CITY OF BOULDER
PLANNING BOARD AGENDA ITEM
MEETING DATE: March 3, 2016

AGENDA TITLE: Public hearing and consideration of a Site and Use Review (LUR2011-00071) to redevelop the site located at 4403 Broadway Ave. with a new mixed use development. The western portion of the site, zoned RM-1 (Residential – Medium 1) would include twelve 3-story townhome units divided between two buildings. The eastern portion of the site, zoned MU-2 (Mixed Use – 2), would include three new mixed use buildings containing an additional 16 attached residential units above 9,207 sq. ft. of commercial and restaurant space. The proposal includes a request for a height modification to allow for both townhome buildings and two of the mixed use buildings to exceed the 35 foot height limit for the zone (requested heights range from 36’3” to 43’6”) as well as a request for a 5% parking reduction to allow for 57 parking spaces where 60 are required. The proposal also includes a Use Review request to allow for three restaurants which close after 11:00 p.m., two of which are over 1,000 sq. ft. in floor area. The applicant is seeking to create vested property rights as provided for in section 9-2-19, B.R.C. 1981.

P

OPEN SPACE DIAGRAM

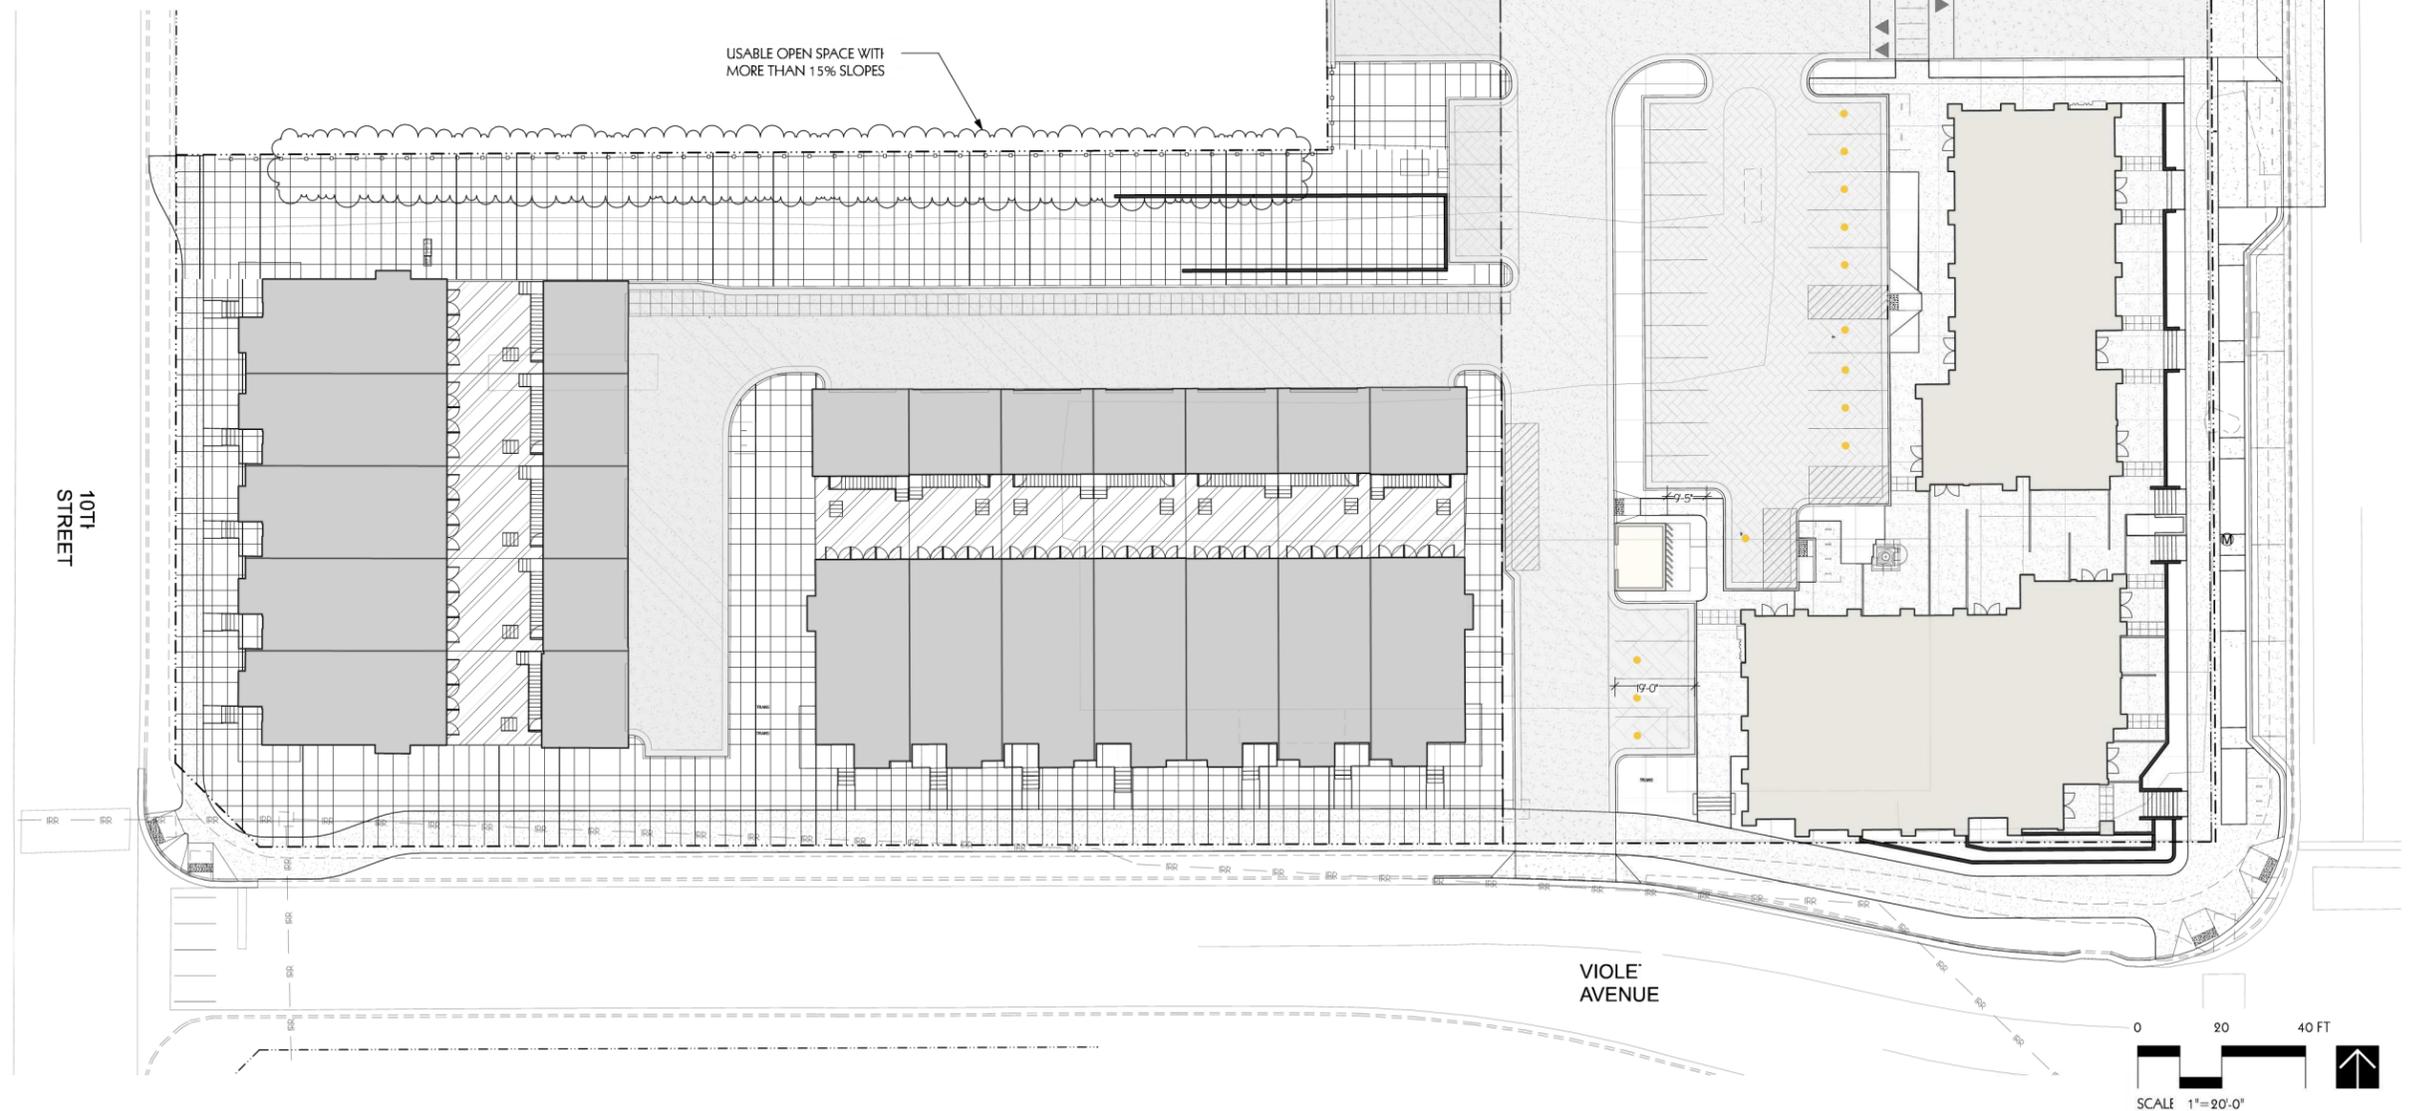
3. Revise the Open Space Plan provided on Sheet SR-A1.02 to include a breakdown of the types of private open space being counted towards the 25% of the required area using the revised numbers as discussed above. The table should provide a total area for the garage decks as well as the courtyard areas and any other private decks or balconies being included. The open space diagram also has several inconsistencies which should be fixed. These include showing several individual townhouse decks as "site open space," including stairways as "private open space," and not labeling the garage decks.

SR-L1.01

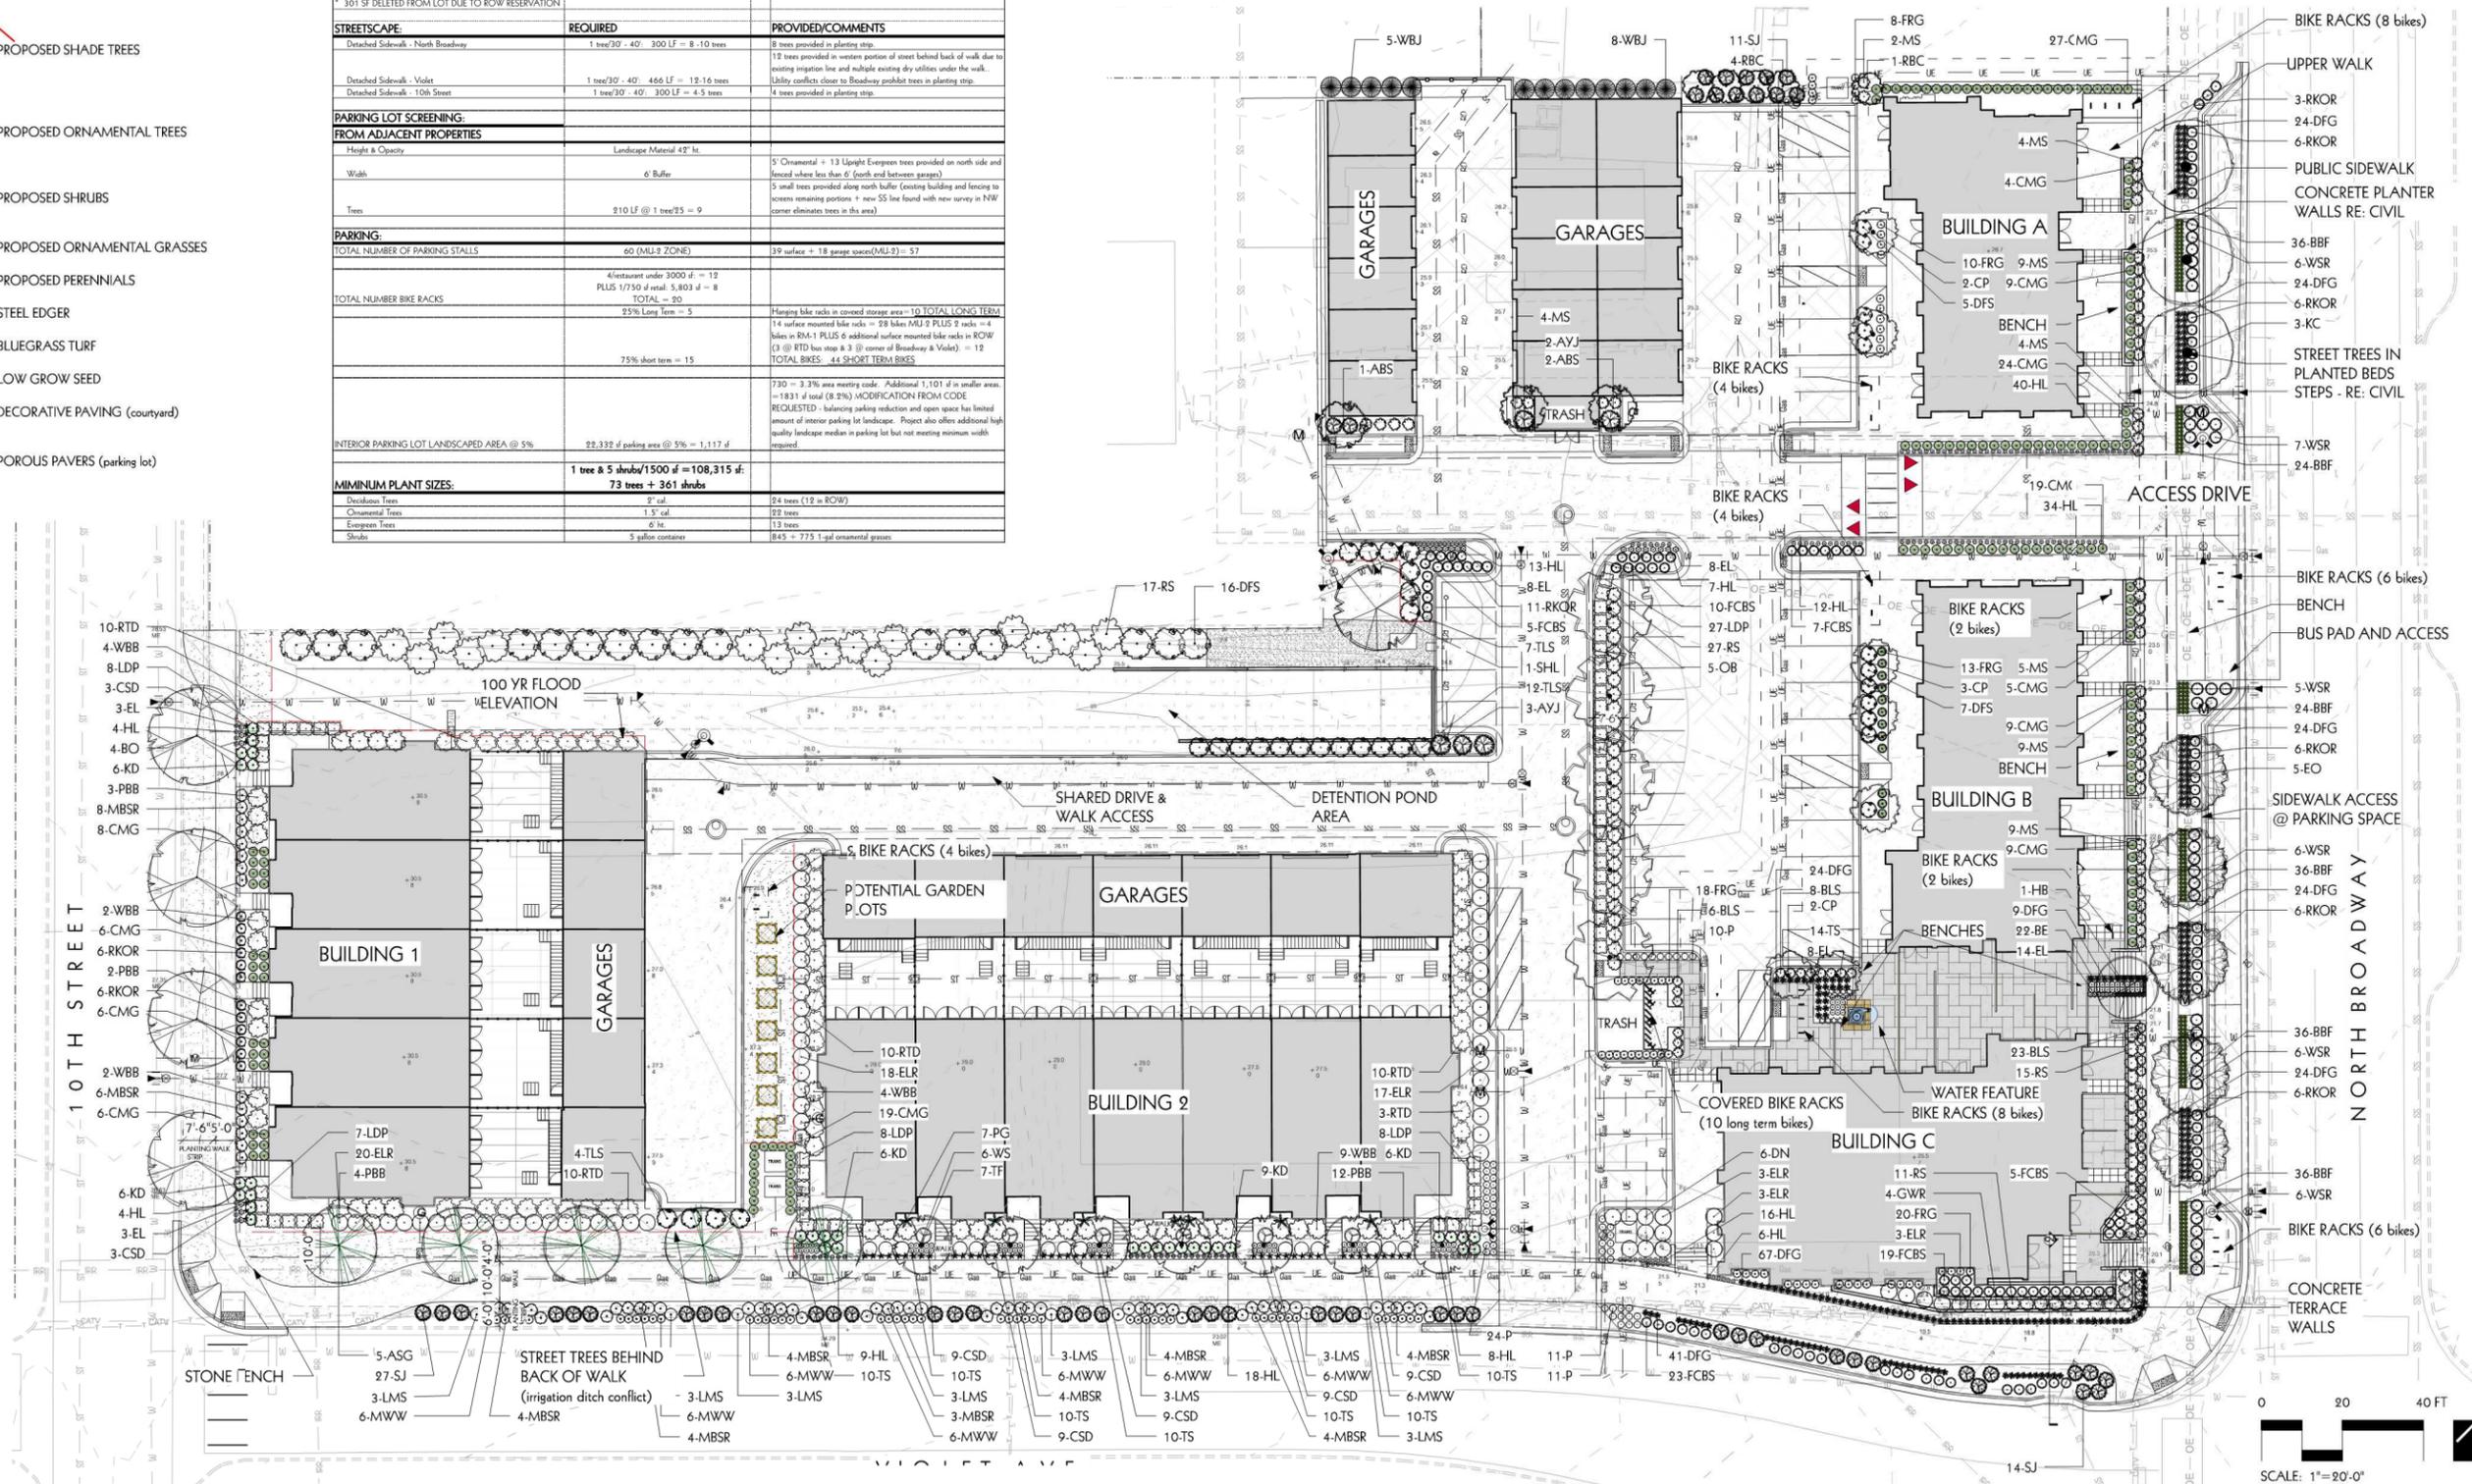
3. The written statement references living walls. Please clarify the extent and treatment of the proposed walls. Are they only on Building C as labeled on Sheet L1.0? Illustrate the system, label the proposed plants and supply sufficient information to verify the associated soil volume.

SR-L1.03

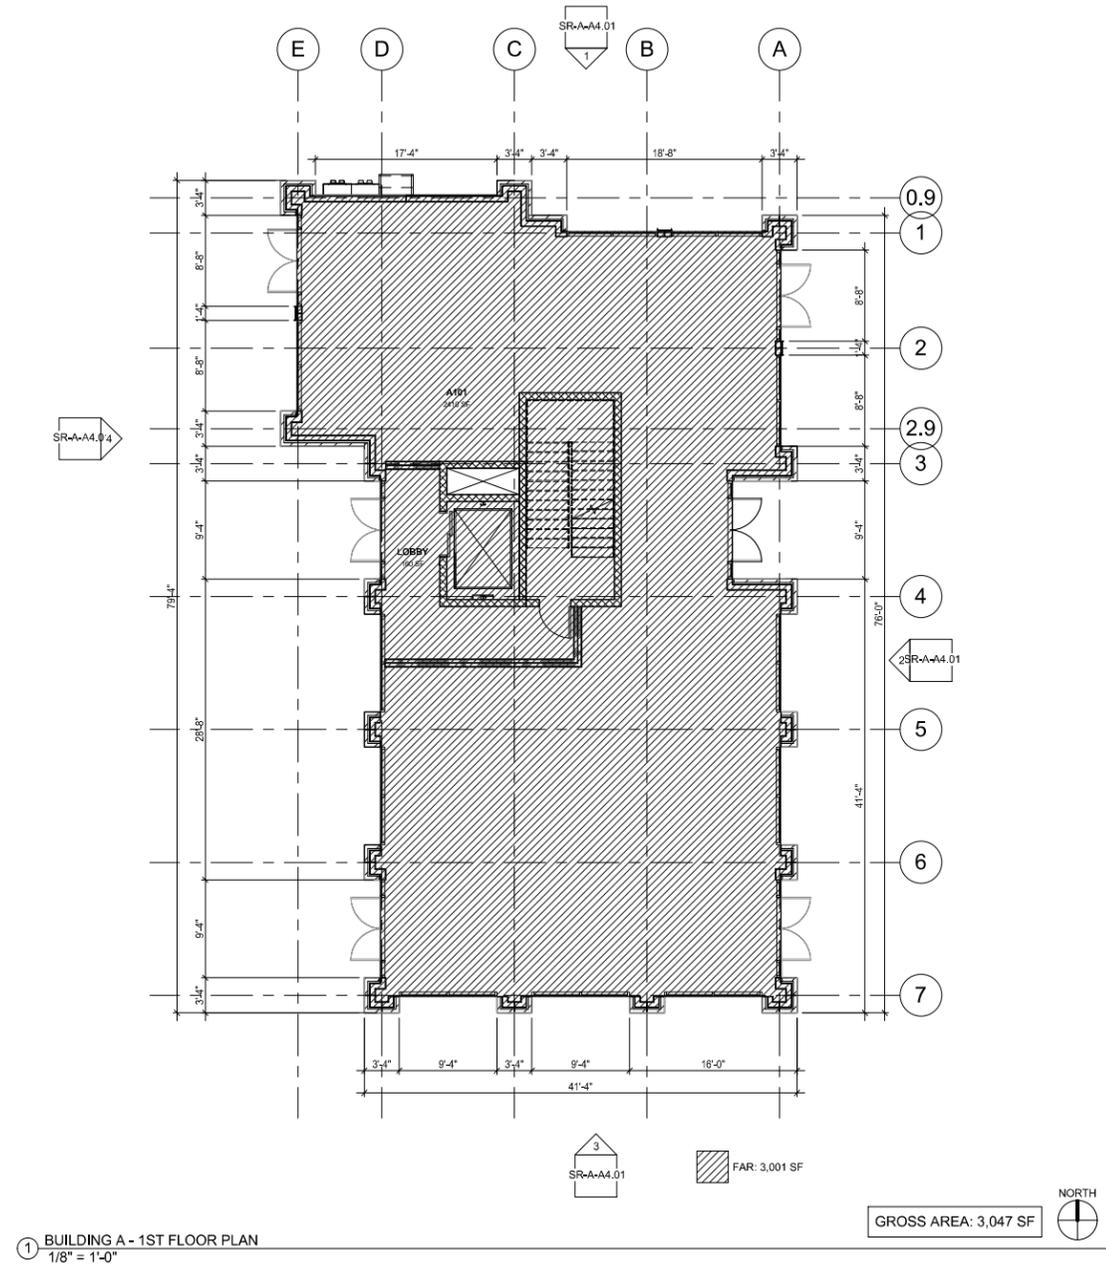
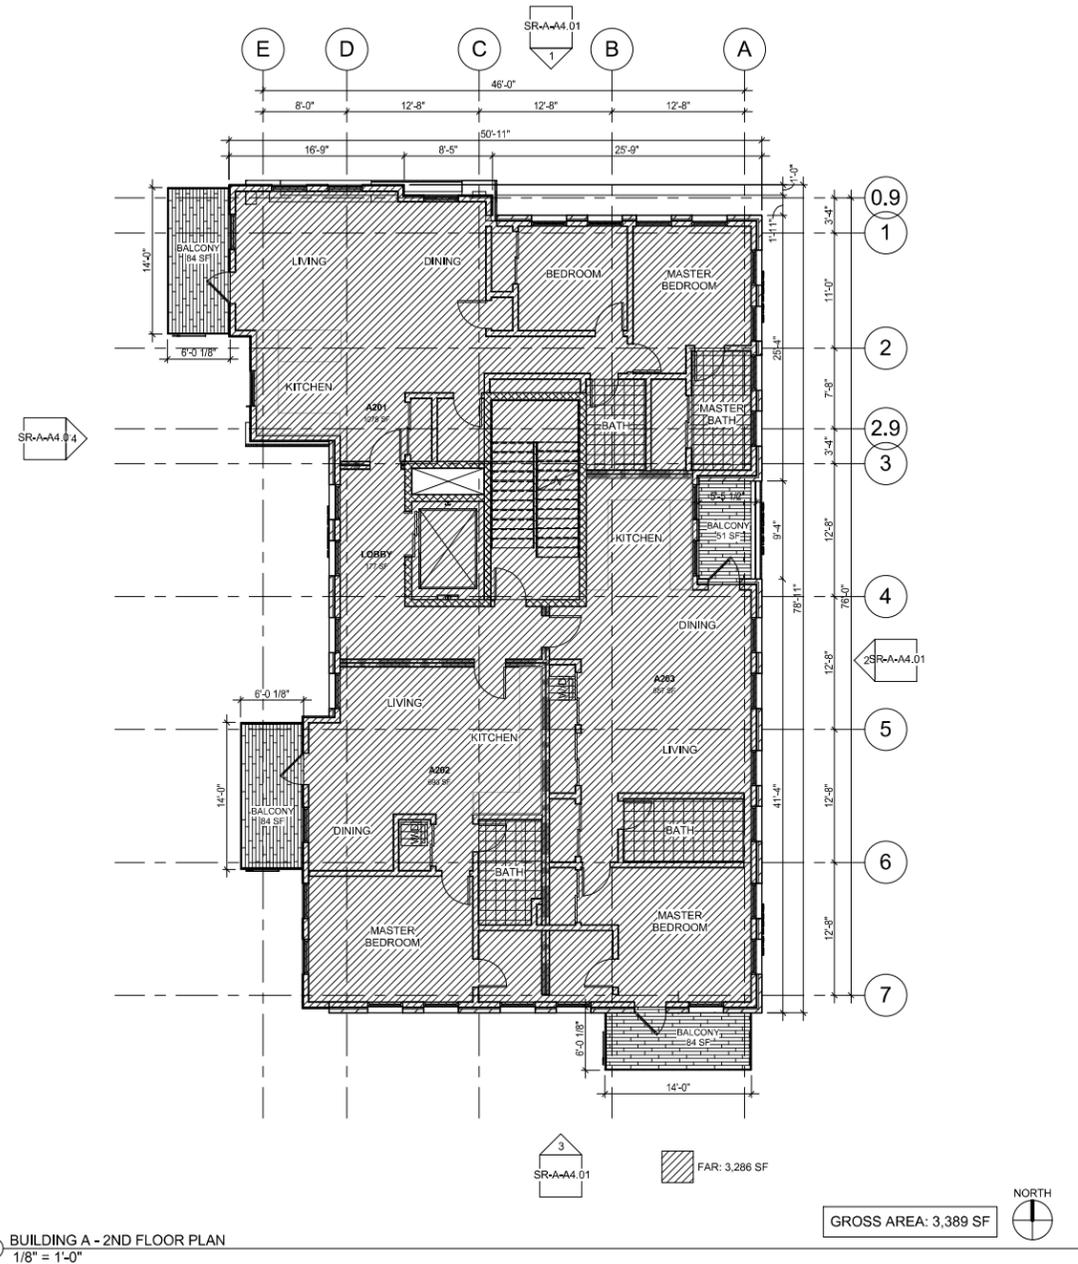
1. Recalculate the interior parking lot screening based on the minimum dimensional standards (eight ft. in any dimension and 150 sq. ft.) and revise the requirements table accordingly. The graphic on sheet L.1.03 and the requirements table on sheet L1.01 have different total square footages for interior landscaping as well. Update the diagram illustrating the interior landscape as well.

2. Review and update the interior parking lot landscape chart on sheet SR-L1.03 to accurately call out all dimensions. ALL landscape related dimensions are in reference to soil volume and may not include curbs.
Update the layout and civil plans as needed. Do not dimension curbs. Most of the landscaping currently included does not appear to meet minimum standards, either because it is not 8 foot in width per section 9-9-14(d)(8) B.R.C. 1981, or because it is actually perimeter landscaping which does not contribute for parking lots of this size. Please note the minimum interior landscaping is 5 percent.
